MEMBER REPORT

DAMAGE EVALUATION

2nd Floor, FC1: C22' (i2655) - 2 such damaged joists 1 piece(s) 14" TJI® 110 @ 24" OC

ForteWEB Software Operator Raj Honnavara P.E. (TX, CO, OK, LA, NM) Weyerhaeuser (972) 478-6831 raj.honnavara@weyerhaeuser.com Job Notes Lot 23 Duncan Crossing, Smith Douglas Homes - McGinnis Model TC #142168

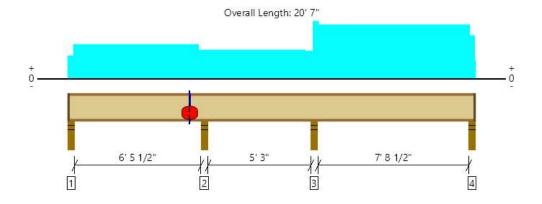
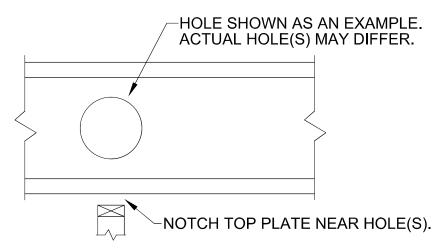
Shear (lbs)			
Holes (Size)	Width	Height	Vertical Offset	Location	Actual	Allowed	Result	Comments
1 - Slotted (M)	7.00"	6.00"	9 1/2"	6' 2"	210	-	Fails	Hole too close to bearing, repair per notes

Shear (lbs)		Moment (Ft-lbs)		Deflection (in)			
Location Analysis	Actual	Allowed	LDF	Actual	Allowed	LDF	Live Load	Total	Comments
1 - <mark>6' 2"</mark>	-179	1860	1.00	-81	3740	1.00	0.002		1 3/4" wide x 4" long x 1/4" deep (max) bottom flange notch at hole- Passes as is

This joist is Structurally Inadequate with the hole being too close to support 2 as shown above. To remedy this situation, notch the top plate at support 2, by 1 1/2", so that the joist is not supported at that point, be cautious not to damage the bottom flange of the joist. This will eliminate one of the supports, and the joist will clear span about 12' in that area. See calculation shown on pages 3 & 4 that reflects this condition.

2nd Floor, FC1: Repaired C22' (i2655) - 3 such damaged joists 1 piece(s) 14" TJI® 110 @ 24" OC

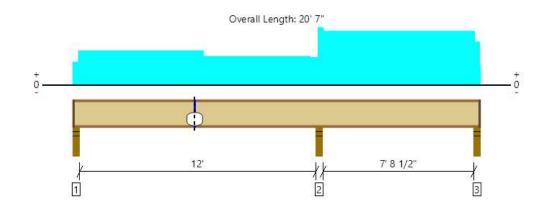
Shear (lbs)			
Holes (Size)	Width	Height	Vertical Offset	Location	Actual	Allowed	Result	Comments
1 - Slotted (M)	7.00"	6.00"	9 1/2"	6' 2"	210	673	Passed (31%)

Shear (lbs)			Moment (Ft-lbs)			Deflection (in)		
Location Analysis	Actual	Allowed	LDF	Actual	Allowed	LDF	Live Load	Total	Comments
<mark>1 - 6' 2"</mark>	-73	1860	1.00	657	3740	1.00	0.034	0.045	1 3/4" wide x 4" long x 1/4" deep (max) bottom flange notch at hole- Passes as is
